Project	IEEE 802.16 Broadband Wireless Access Working Group < http://ieee802.org/16 >	
Title	Add “sub-segment” to the PUSC mode	
Date Submitted	2004-11-04	
Source(s)	John Lee, Gang Yu, Yongmao Li HUAWEI No.98, Lane91, Eshan Road, Pudong Shanghai, P.R. China, 200127	Voice: 86-21-68644808 Fax: 86-21-50891851 mailto: John_Lee@huawei.com yug@huawei.com lymao@huawei.com
Re:	Contribution on comments to IEEE P802.16e/D5	
Abstract	According to the current OFDMA PHY Specification, subchannels are divided and assigned to three segments in PUSC mode that can be allocated to three different sectors of the same cell. While three sectors are not enough to deploy a cellular network with frequency reuse factor one. We propose to add “sub-segment” to the PUSC mode. Correspondingly we introduce the way to arrange the preamble and the FCH of the sub-segment .	
Purpose	Adoption	
Notice	This document has been prepared to assist IEEE 802.16. It is offered as a basis for discussion and is not binding on the contributing individual(s) or organization(s). The material in this document is subject to change in form and content after further study. The contributor(s) reserve(s) the right to add, amend or with

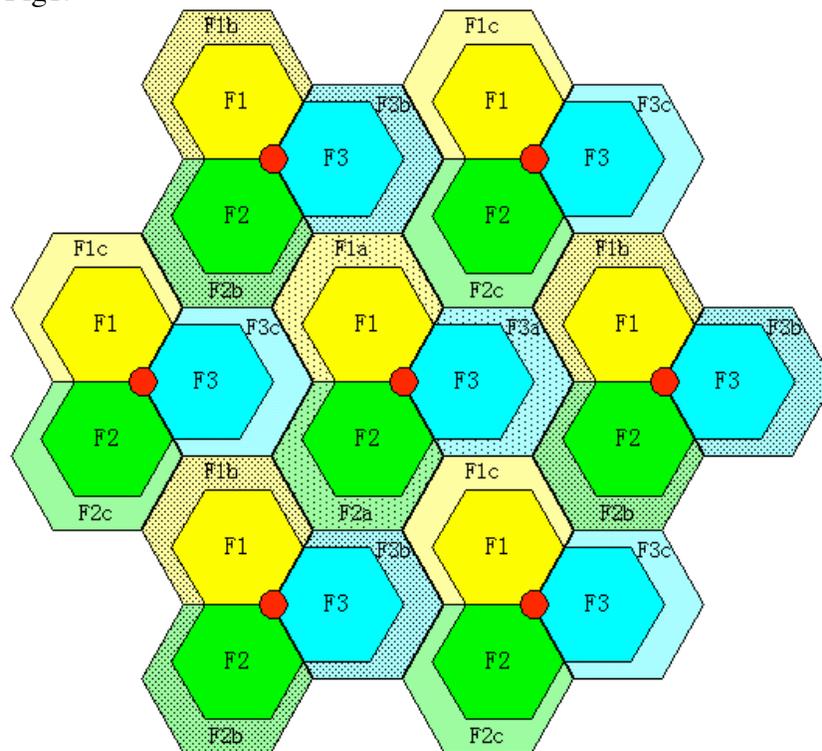
We propose to add “sub-segment” to the PUSC mode. The sub-channels in one segment are further divided into 3 sub-segment. By using power control, BS make the sub-channels in one of the sub-segment fully cover the whole sector and other sub-channels in the segment just cover the area near itself. So MSS near the BS can use all the channels in the segment and the MSS at the edge of the cell can only use the sub-channels in sub-segment. This is demonstrated in Fig1.

Figure 220 FCH subchannel allocation for all 3 segments

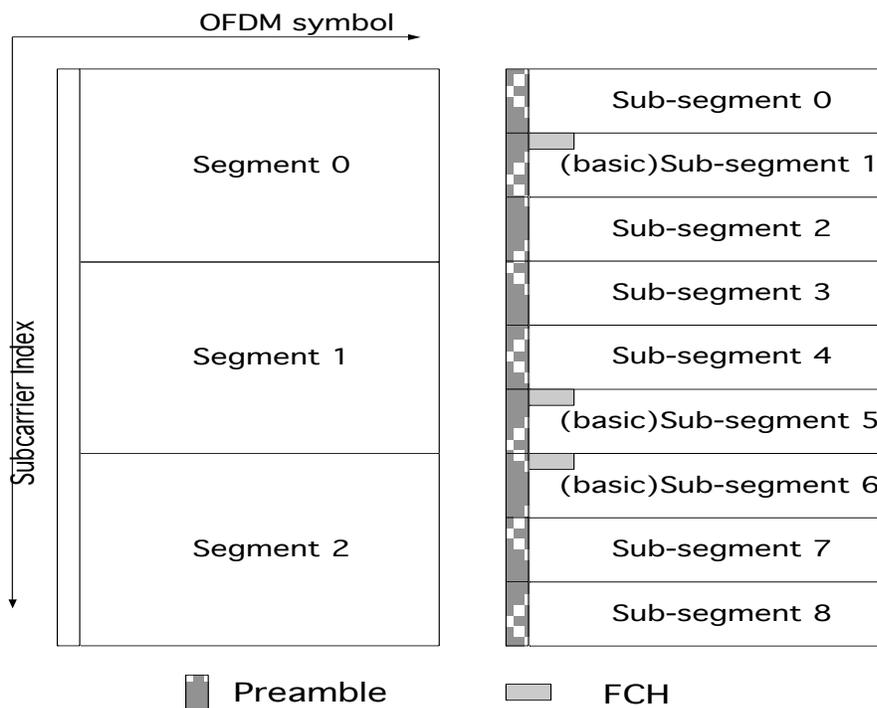
8.4.4.4 Allocation of subchannels for FCH, and logical subchannel numbering

In PUSC, any sub-segment used shall be allocated at least 12 subchannels. The first 4 slots in the downlink part of the basic sub-segment contain the FCH as defined in 8.4.4.2. These slots contain 48 bits modulated by QPSK with coding rate 1/2 and repetition coding of 4. Figure 220 depicts this structure.
